CONNECTION ASSESSMENT & APPROVAL PROCESS

PRELIMINARY ASSESSMENT REPORT

For Hydro One's Proposal to Quarter Terauley TS

CAA ID No. 2001-050

DIAGRAM 1

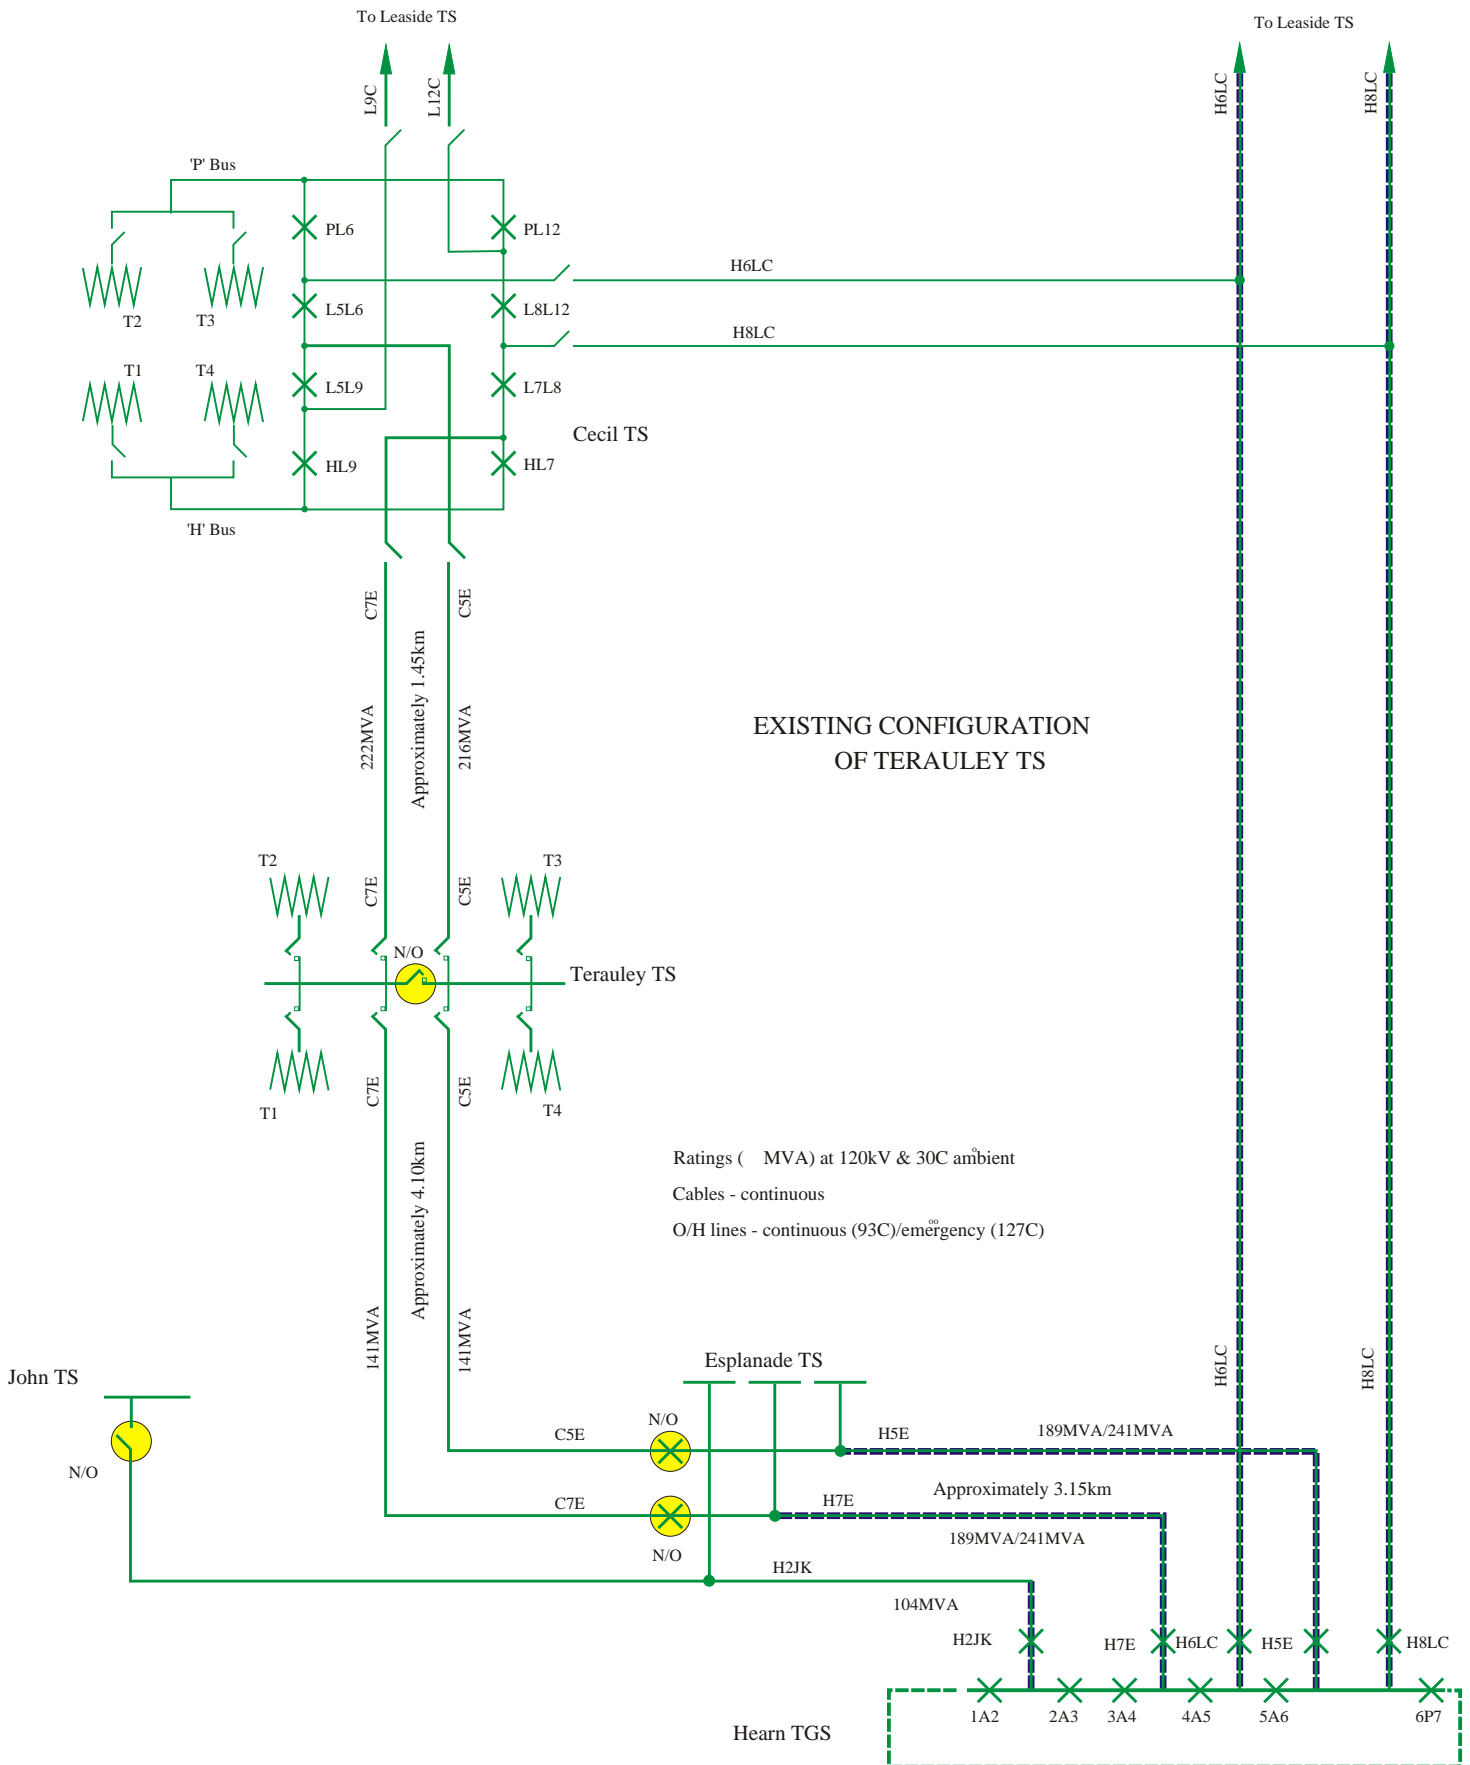
Diagram 1 shows the existing configuration of the facilities at Terauley TS and its location in relation to Cecil TS and Hearn TGS. It also shows the typical operating arrangement with the two circuit breakers at Esplanade TS operated normally-open.

DIAGRAM 2

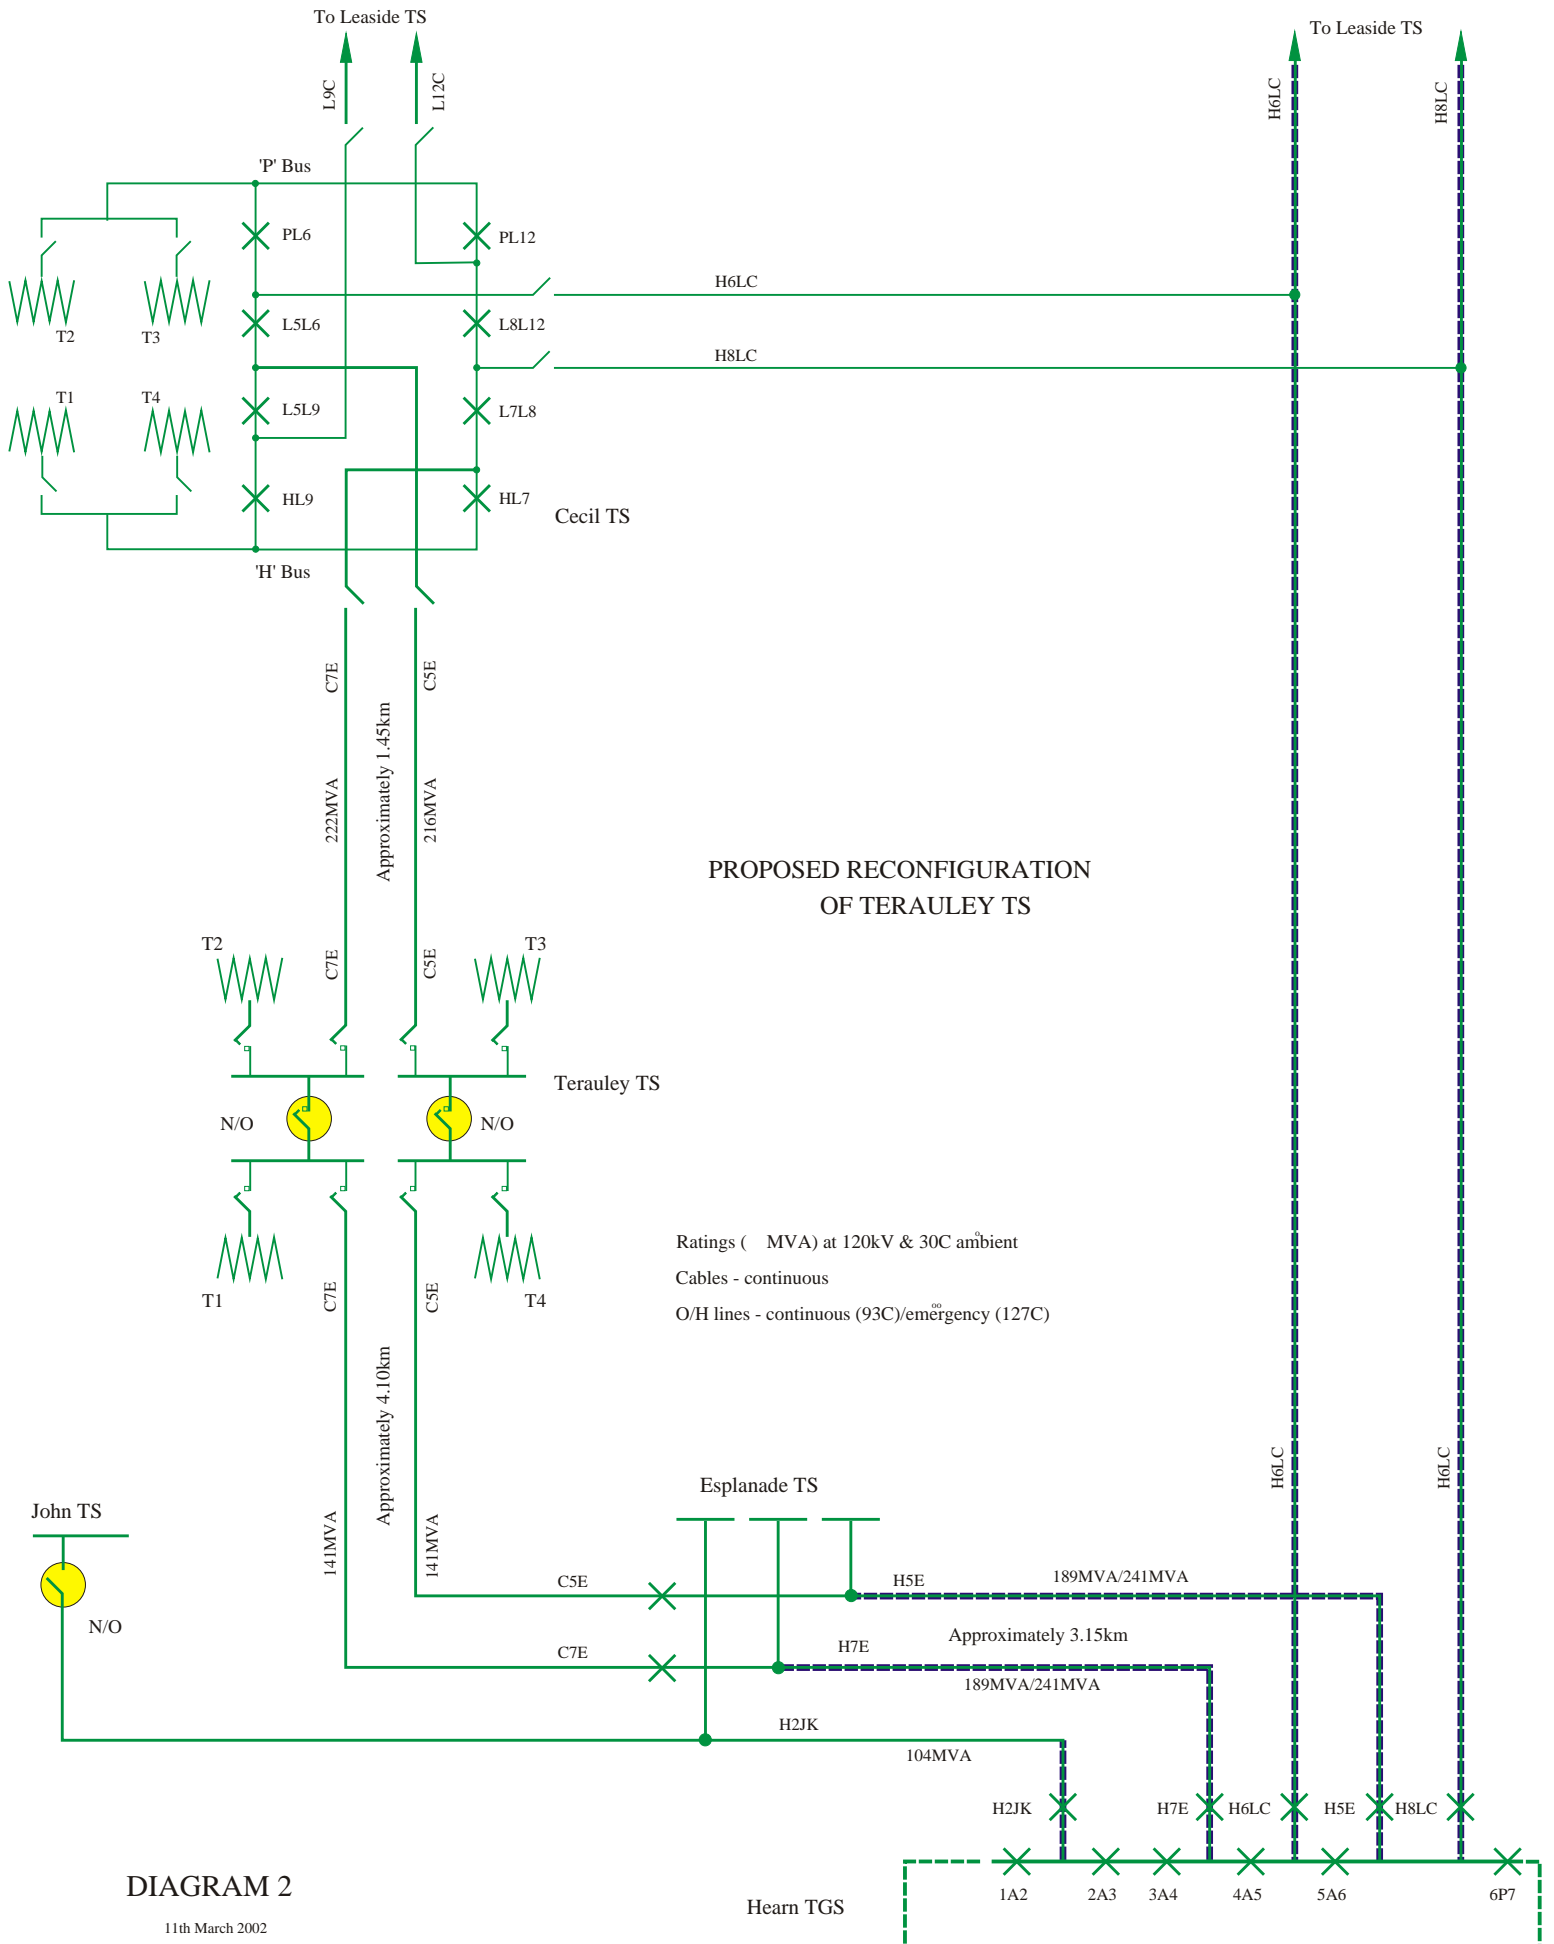
Diagram 2 shows the arrangement once the two new circuit-switchers have been installed at Terauley TS and the normally-open points between Cecil TS and Hearn TGS have been relocated from Esplanade TS to Terauley TS. With the new circuit-switchers at Terauley TS operated normally-open, the 115kV supply at that TS would be 'quartered'. This would mean that the supply to Terauley TS would be obtained from four discrete radial circuits that are each terminated through a dedicated transformer.

DIAGRAM 3

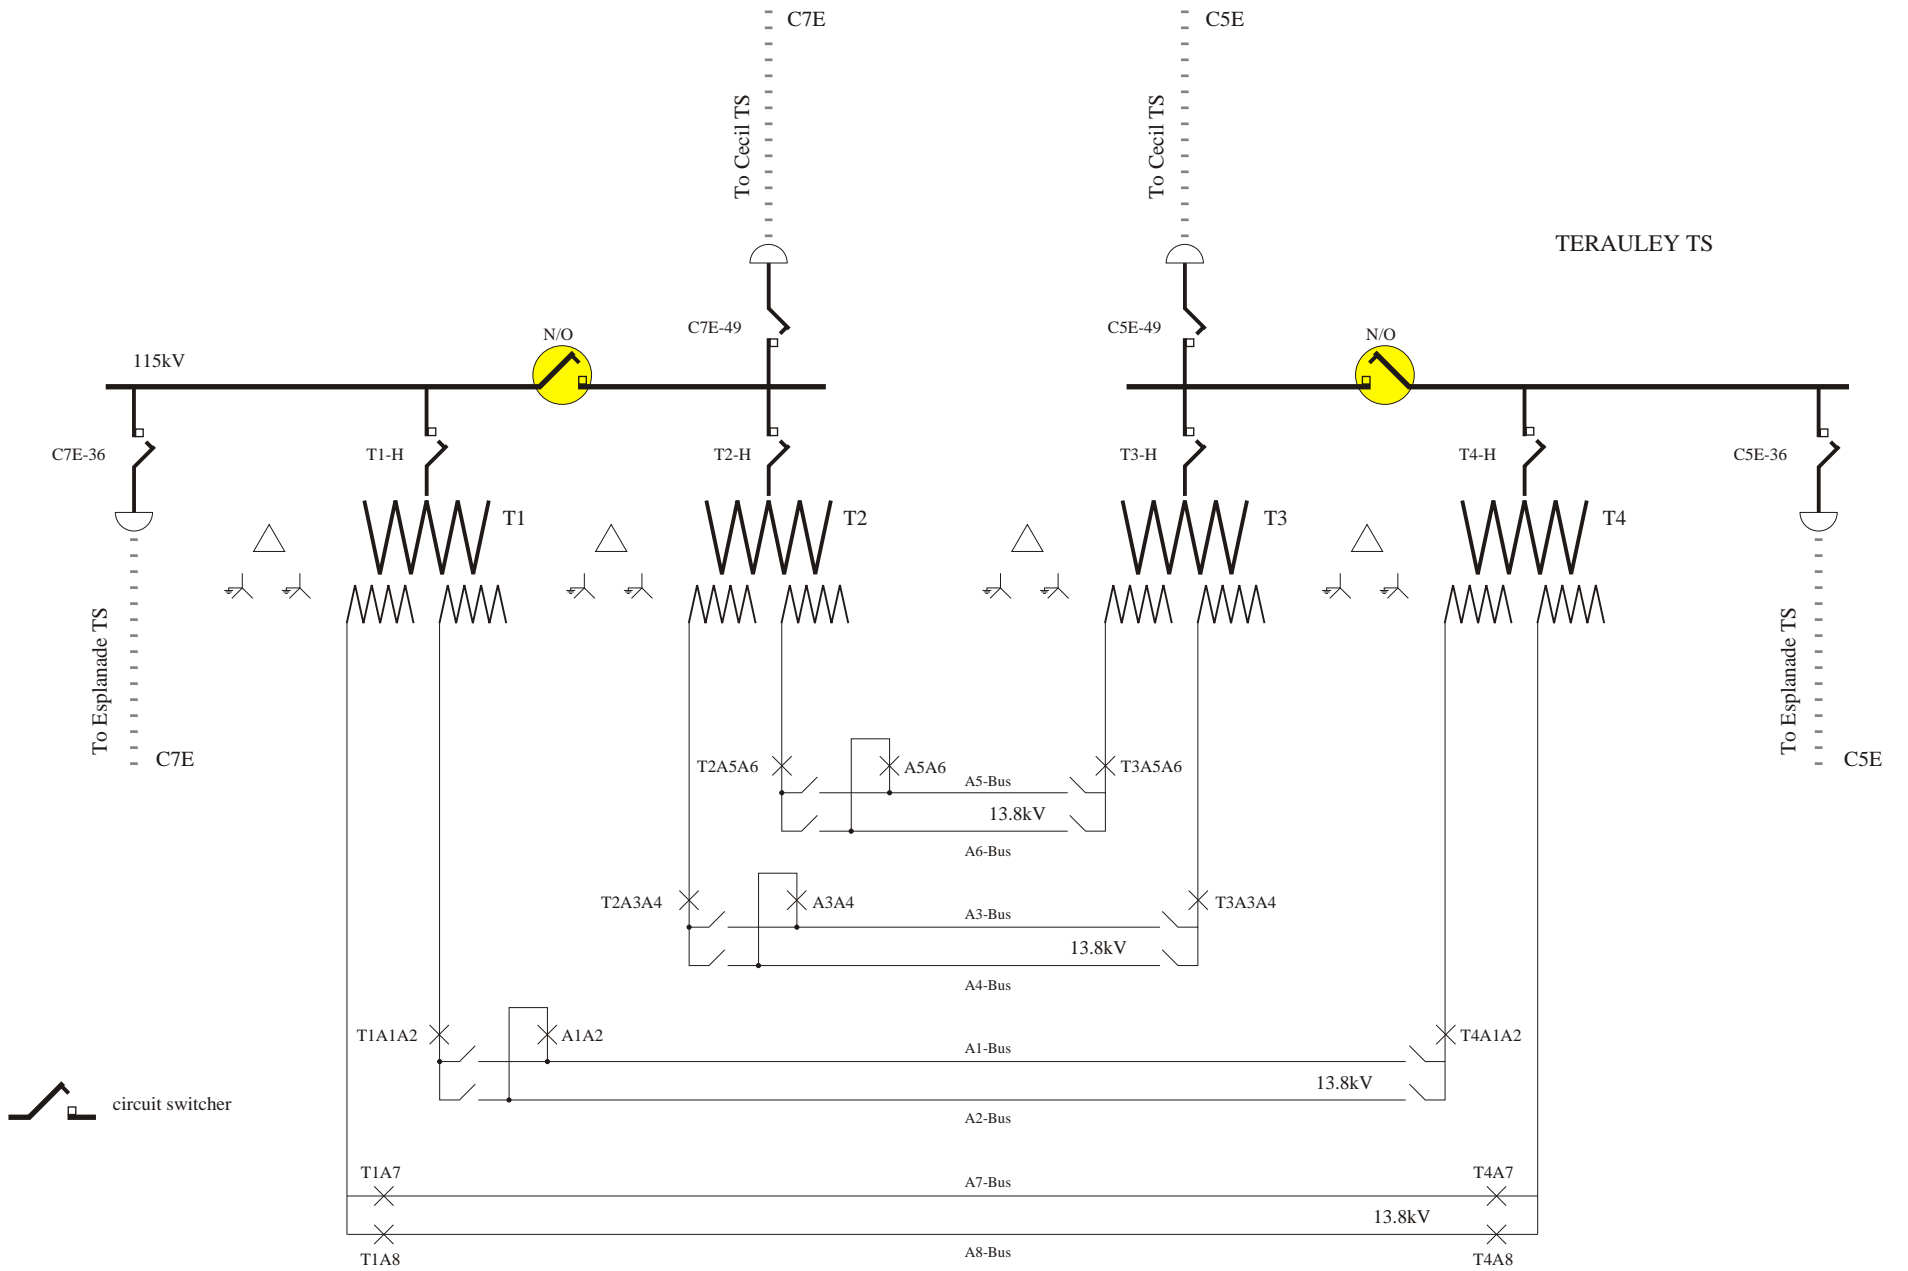
Diagram 3 provides a more detailed view of the facilities at Terauley TS once the two new circuit-switchers have been installed and the TS is operated 'quartered'.
